## **VILLAGE 7 SUBDIVISION**

### **ELLENBROOK**

### **ACOUSTIC ASSESSMENT**

### **ELLENBROOK VILLAGE 7B SPEEDWAY NOISE PROPOSED NOISE CONTOUR FOR NOTIFICATIONS ON TITLES**

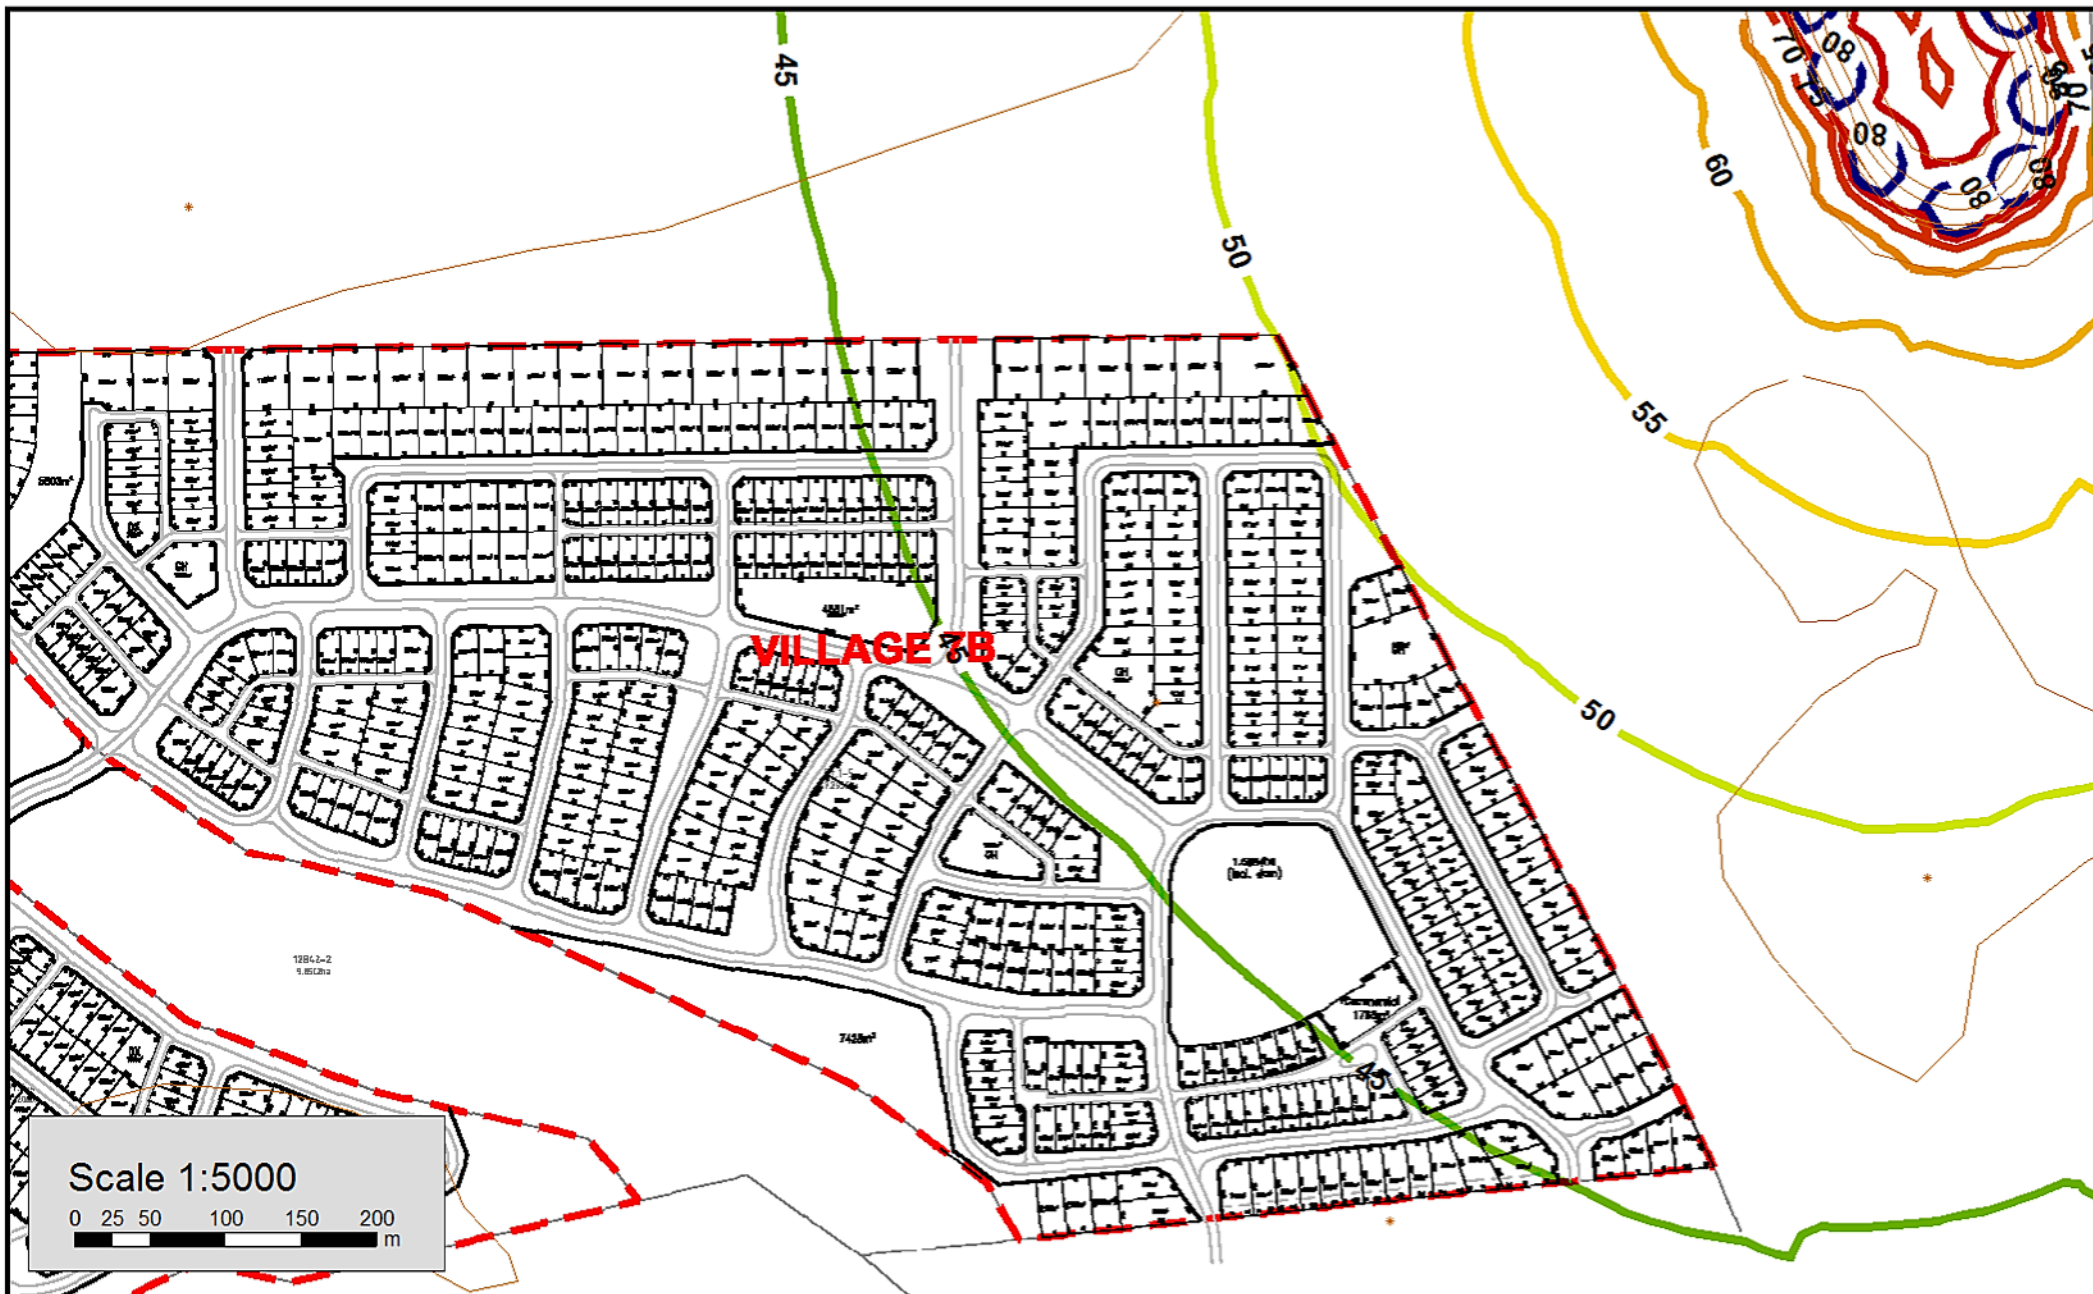
In summary, we believe that the Council's position regarding the lots requiring notifications on titles is that:

- 1. Regardless of any alternative, basically compliance needs to be achieved with the Environmental Protection (Noise) Regulations 1997.*
- 2. Council contention is that section 70A notifications be required where your model predicts external noise exposure at 45 dB(A) and above (i.e. where levels are predicted to exceed the 'assigned levels' of the Regulations).*

From monitoring undertaken, of a race meeting (including Late Model Sedans) the  $L_{A10}$  noise level is 3 dB(A) less than the  $L_{Amax}$  noise level. Based on this differential of 3 dB(A), the  $L_{A10}$  noise contours have been determined and are attached for information as Attachment 1. It should be noted that the noise contours shown in Attachment 1 are without any development having been undertaken.

Taking Council's position into consideration, then it is recommended that the 45 dB  $L_{A10}$  noise contour be used to determine the lots requiring Notifications of Titles. However, given the barrier affect afforded by residential buildings, we recommend that the 45 dB(A) for the  $L_{A10}$  noise contour, as shown on Attachment 2 (with the residence in place) be used as the bases of the lots requiring Notifications on Titles. For information, based on the 45 dB(A) noise contour shown on Attachment 2, the Lots requiring Notifications on Titles are shown on Attachment 3.

VILLAGE 7B - LA10 NOISE CONTOUR PLOT FOR ALL WIND SCENARIOS at 3 METRES PER SECOND  
WITH RESIDENTIAL BUILDINGS

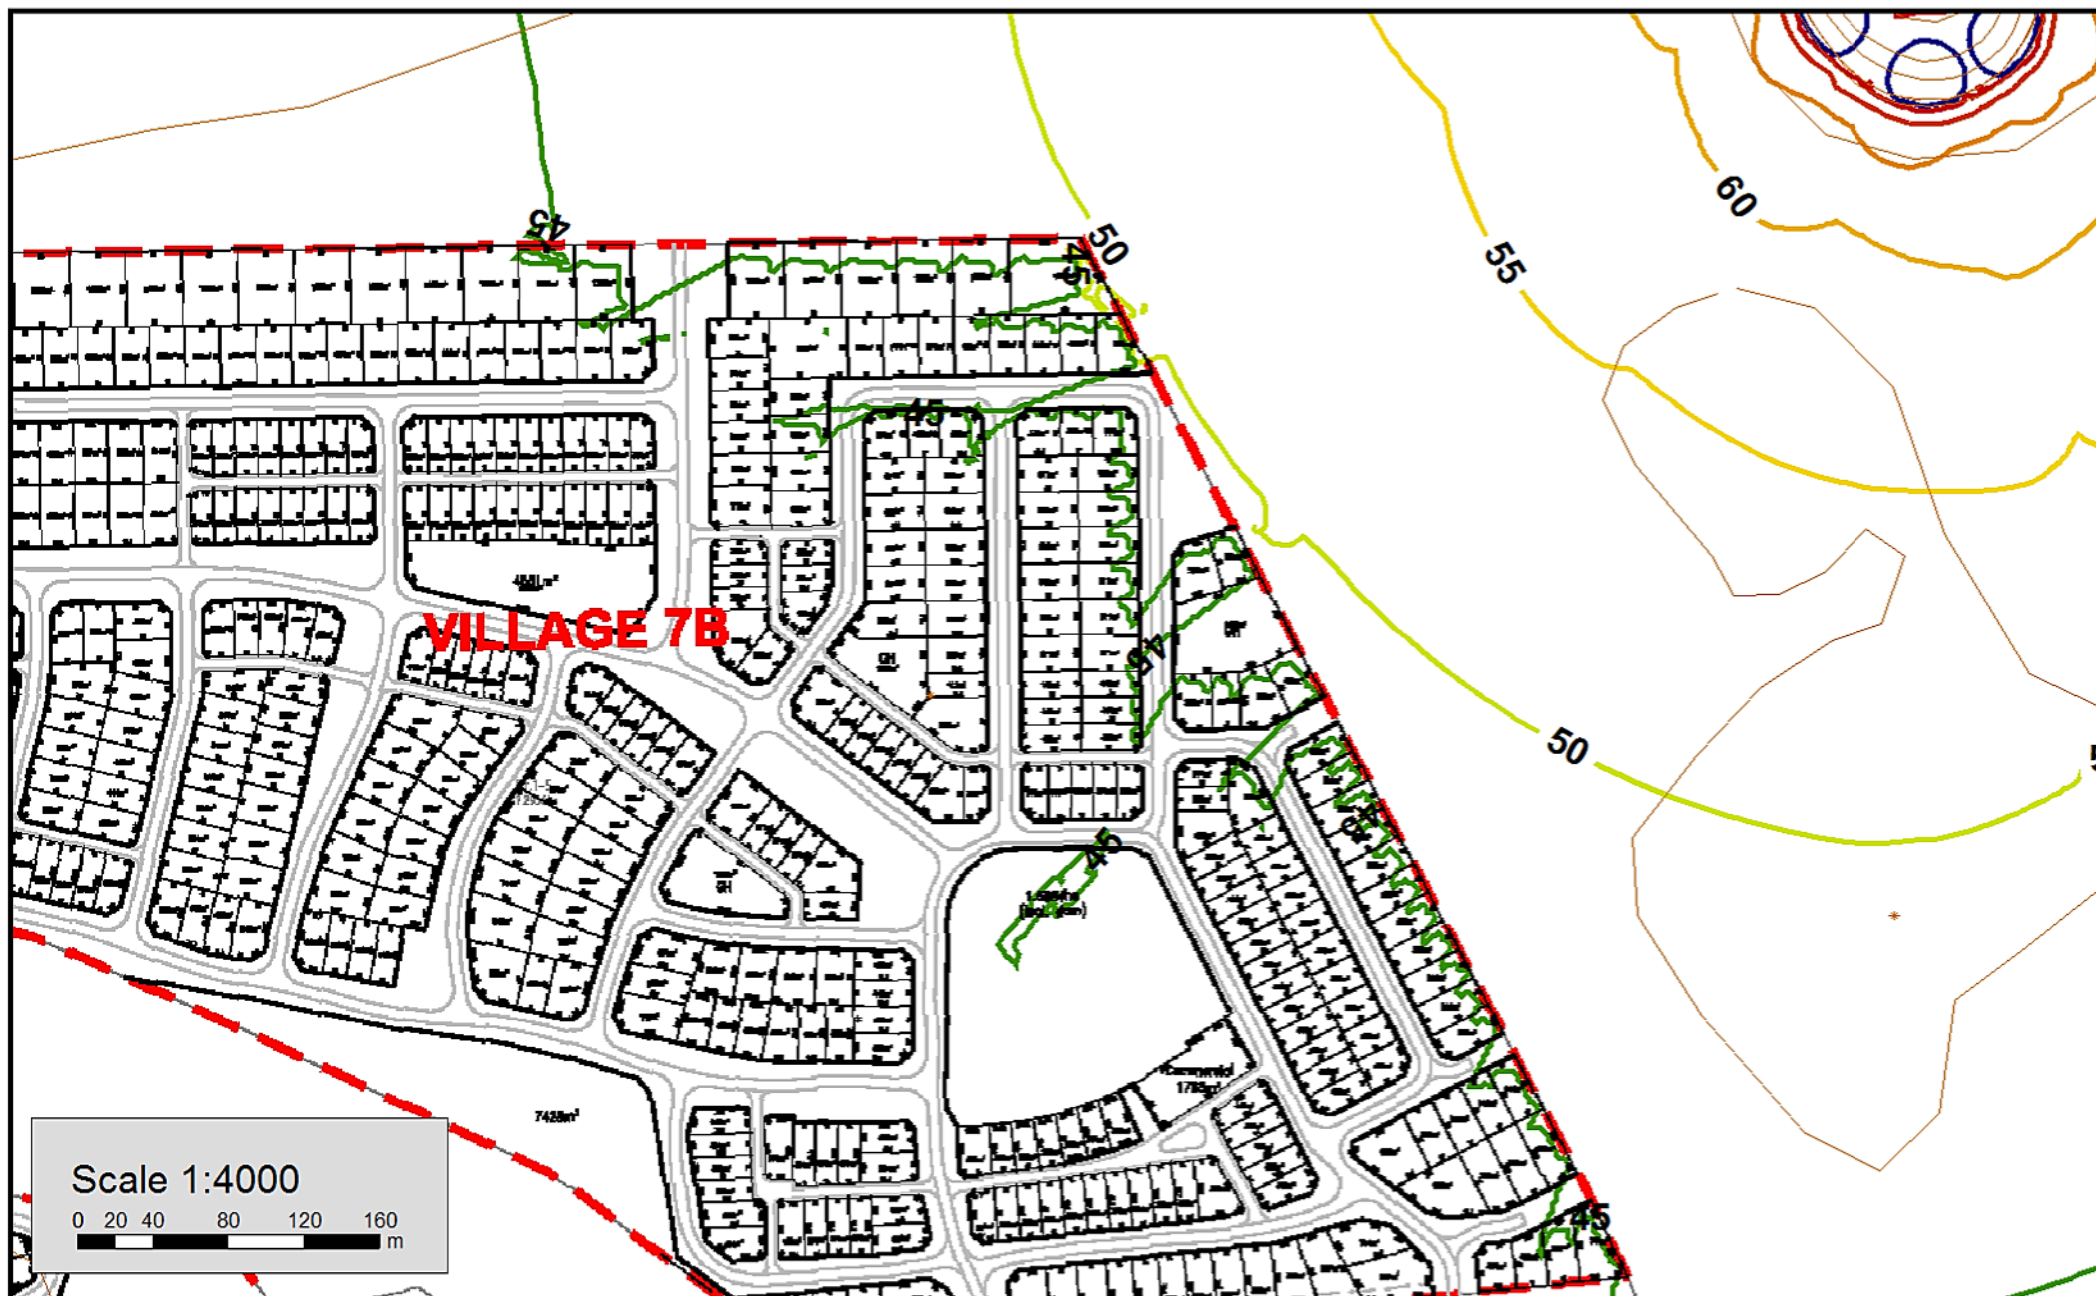
We note that the noise contours shown on Attachment 1, would still be conservative, as they do not include any homes that would be built as part of the residential development. We believe that the first couple of rows of residence would provide a barrier and noise received at the residences behind, would comply with the required Council Criteria. The  $L_{A10}$  noise contours with the residential buildings are attached for information as Attachment 2.
